UNITED STATES PATENT AND TRADEMARK OFFICE

APPLICATION NO.	FILING DATE	FIRST NAMED INVENTOR	ATTORNEY DOCKET NO.	CONFIRMATION NO.
10/724,135	12/01/2003	Hermann Ruckerbauer	INF-117	1211

Office Action Summary

DETAILED ACTION

FIG 1

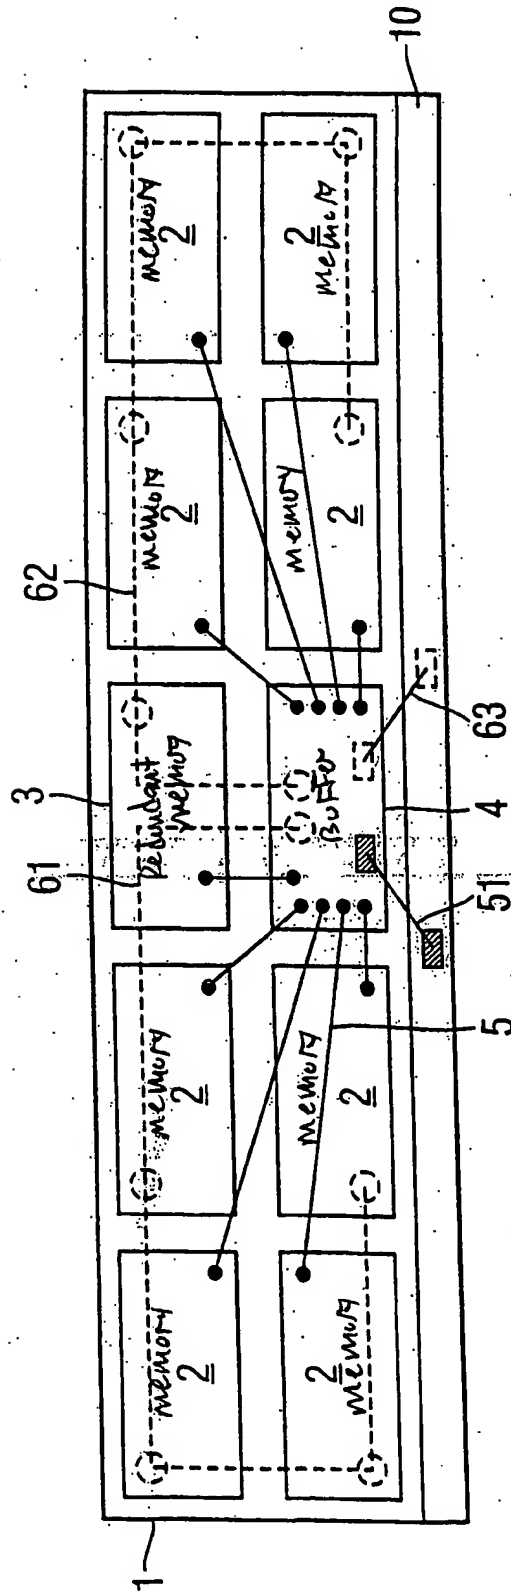
The replacement drawings were received on 9/11/06. These drawings are unacceptable. Although applicant has labeled some of the elements in the replacement sheets, there are some numbered elements that are not labeled on the replacement drawing. Examples: Figure 1 – elements 1, 5, 3 and/or 61 (it is unclear which element the redundant memory is labeling) 62, and 63. The same part numbers are not labeled throughout the remainder of the figures. The drawings are objected to because descriptive labels other than numerical are needed for figures 1-5. See 37 CFR 1.84(o). A proposed drawing correction or corrected drawings are required in reply to the Office action to avoid abandonment of the application. The objection to the drawings will not be held in abeyance.

Figures 1 and 2 should be designated by a legend such as --Prior Art-- because only that which is old is illustrated. See MPEP § 608.02(g). Corrected drawings in compliance with 37 CFR 1.121(d) are required in reply to the Office action to avoid abandonment of the application. The replacement sheet(s) should be labeled "Replacement Sheet" in the page header (as per 37 CFR 1.84(c)) so as not to obstruct any portion of the drawing figures. If the changes are not accepted by the examiner, the

As per claim 2, AAPA teach each of the buffer and error checking modules is connected to an even number of data memory devices for storing the data (see Figure 1).

As per claim 3, AAPA teach the data memory devices are arranged symmetrically with respect to the buffer and error checking module (see Figure 1).
